Site Accessibility Evaluation

Sahwatch Parking Garage

**255 Sahwatch St
Colorado Springs, CO
80903**

Inspection Date: 08/27/2019

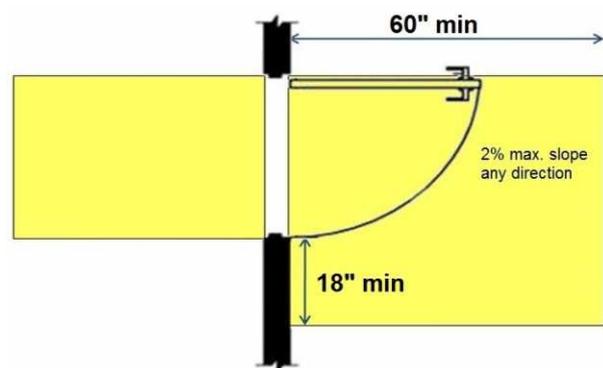
12 inches of maneuvering space on the pull side

Providing the minimum required maneuvering space on the pull side of the door is technically infeasible at this time because existing structural conditions would require removing or altering a load-bearing member that is an essential part of the structural frame; or because other existing physical or site constraints prohibit modification or addition of elements, spaces, or features that are in full and strict compliance with the minimum requirements. Best practice measures are recommended to ensure parking garage is accessible to the maximum extent possible.
